**Advisory Action  
Before the Filing of an Appeal Brief**

10/786,139

TITLE: MINE SIFTING ATTACHMENT HAVING TRANSVERSE BLADES  
INVENTOR: CHRISTOPHER J. WANNER  
APPLICATION SERIAL NO. 10/788,139  
DOCKET NO. NVL 3289

Fig. 2

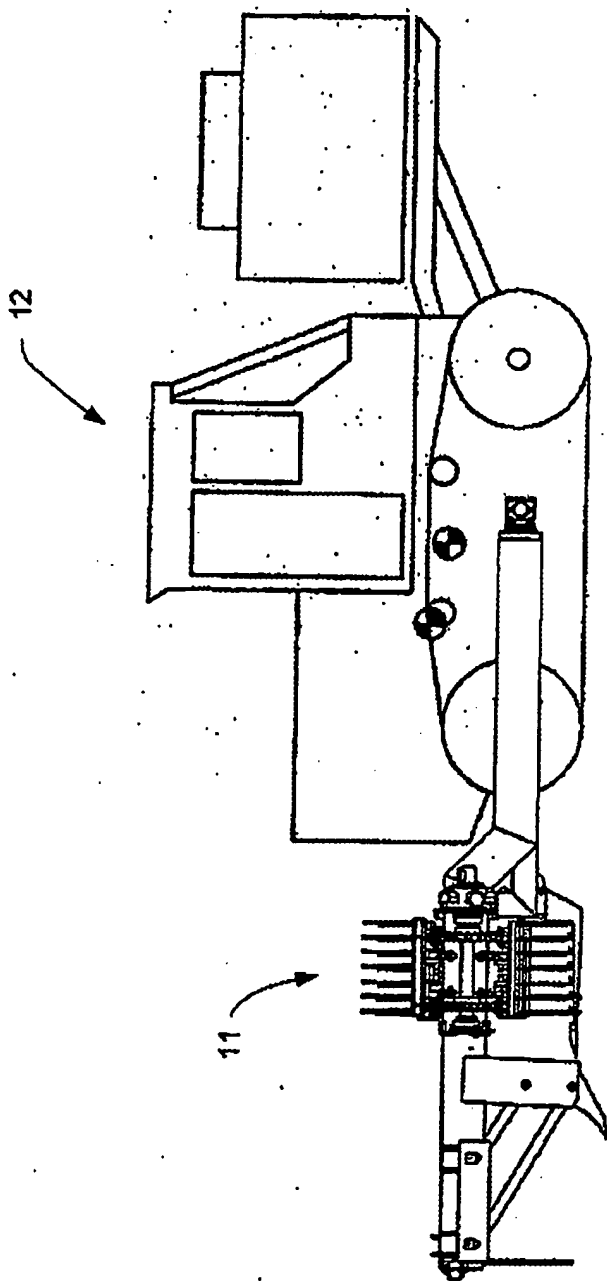
Continuation of 3. NOTE: Proposed Fig. 2 raises the issue of new matter because applicant has provided details on the tractor that do not have basis in the original disclosure. The examiner suggests submitting a different Fig. 2 that does not include specific tractor details. The examiner suggests representing the tractor with a box diagram, with the minesweeper attached, and with the front and/or rear of the tractor as well as the direction of travel indicated. The proposed changes to the claims and specification would have been acceptable if not for the drawing issues.
